August 17, 2015

From: Kit H. Custis
CA PG 3942, CEG 1219, CHG 254
P.O. Box 337
Fair Oaks, CA 95628

RE: Additional Comments and Recommendations on Draft Environmental Impact Report for Glenn Colusa Irrigation District's Groundwater Supplemental Supply Project, June 2015

Figure 2. Ideal response curves for stream depletion rate and volume. (from Miller and others, 2007)

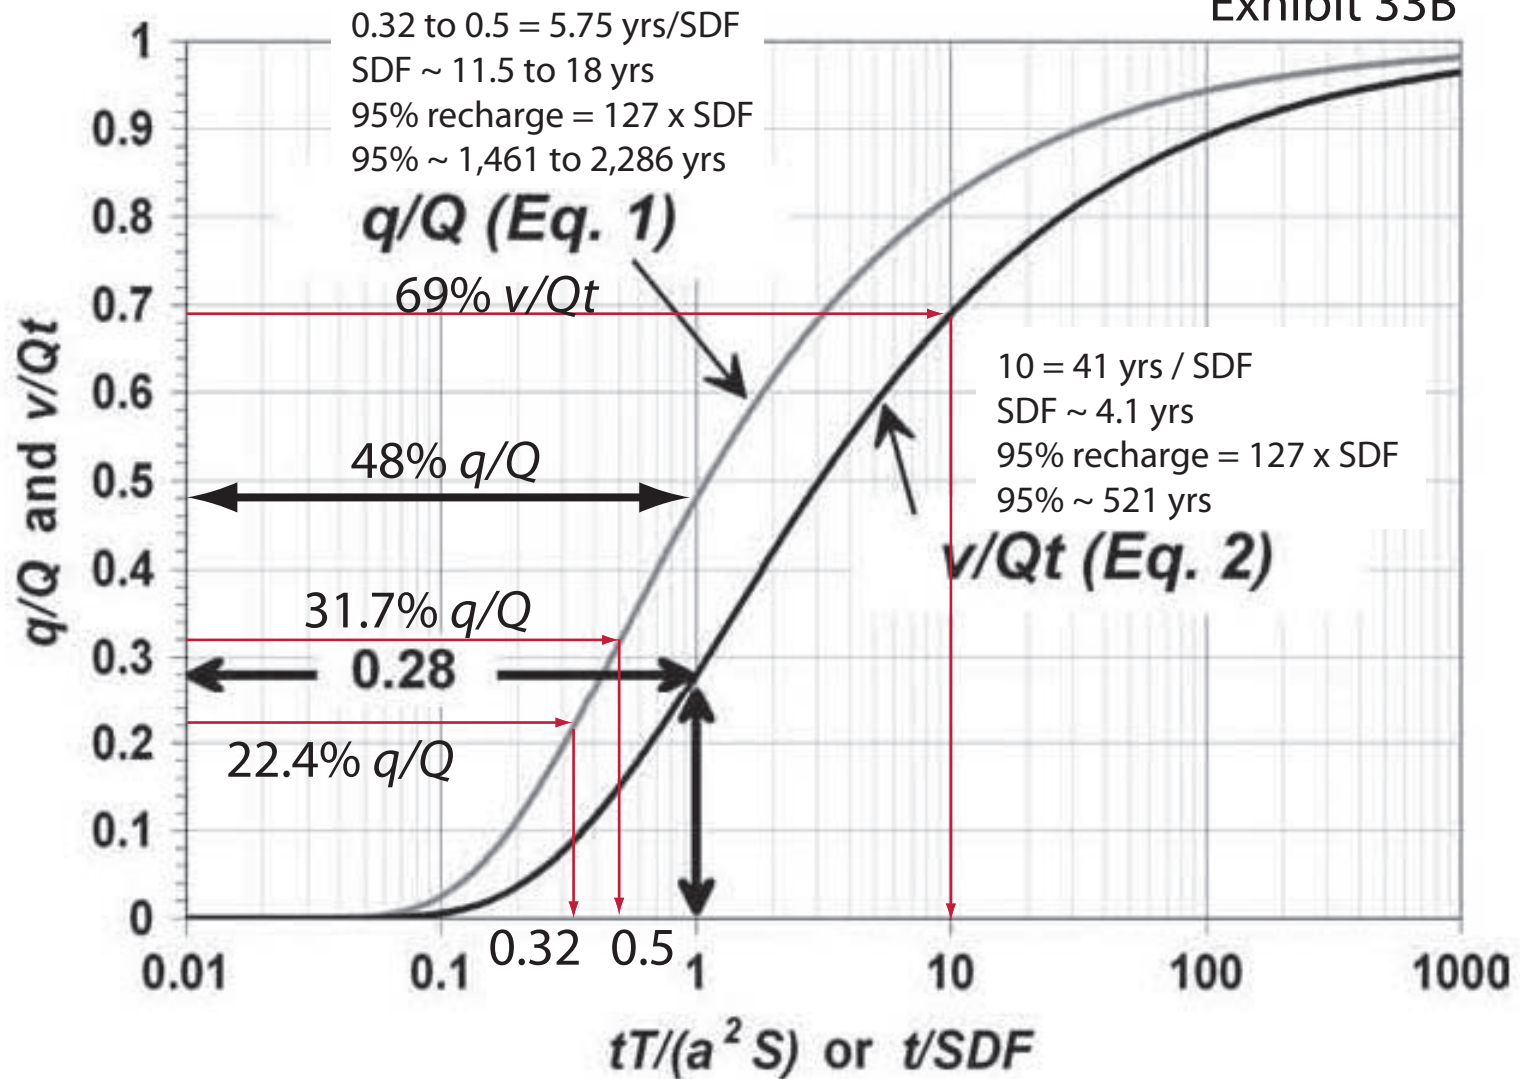
Exhibit 33B is taken from Figure 2 in Miller and others (2007) and shows graphs of the ideal response curves for instantaneous stream depletion rate and cumulative stream depletion volume. The x-axis on this figure shows the logarithm of time from the start of pumping normalized by the time of the SDF. Thus, the value of 1 on the x-axis correlates to a duration of pumping equal to the SDF time. The lower curve relates the cumulative volume of stream depletion to the total volume pumped (v/Qt), while the upper curve relates the instantaneous rate of stream depletion to the total rate of pumping (q/Q). These ideal response curves can be used to estimate the time interval needed to achieve the 95% recharge used by Wallace and others (1999) in the absence of actual simulated stream depletion response curves from each of the GCID project wells. Should simulated stream depletion response curves be provided for each GCID well, then the method given below of calculating the time for 95% recharge can be applied to the GCID project wells.

Exhibit 33B shows that when the duration of pumping equals the SDF ($t/SDF = 1$) the lower curve gives the cumulative stream depletion volume of 28% relative to the total pumped volume. The upper curve gives the instantaneous depletion rate of 48% relative to the total pumping rate. For the Sacramento River, Exhibit 33A gives the maximum stream depletion rate of approximately 22% based apparently on six continuous years of pumping 8-1/2 months per year at the maximum pumping rate of 25,000 gpm or 55.7 cfs, or 31.7% based on a 12-month time-weighted average total pumping rate of 17,705 gpm or 39.45 cfs. The

Sacramento River's maximum depletion rate occurs at approximately 5.75 years after the start of the pumping that simulated the 1987-1992 six-year drought, Exhibit 33A. The 22%- q/Q -value on the y-axis hits the upper curve, relative instantaneous pumping rate, at a t/SDF -value of approximately 0.32. For the time-weighted average 31.7%- q/Q -value, the t/SDF -value is approximately 0.5. Using these values, the range of the group-SDF time for GCID's wells depleting flows in the Sacramento River can be estimated at 11.5 to 18 years ($SDF = t/0.32$; $SDF = 5.75 \text{ years} / 0.32 = 18 \text{ years}$). The SDF values for the other streams could be calculated in a similar manner.

I recommend that the DEIR be amended to address the issue of what duration is required to fully recharge the volume of groundwater taken from storage by the GCID project wells. This discussion should include providing stream depletion response curves for each GCID project well and any alternative well so the impacts from each well can be evaluated. I also recommend that the DEIR include a mitigation measure that uses the stream depletion response curves for each well to forecast the impacts on stream flow from each new pumping event.
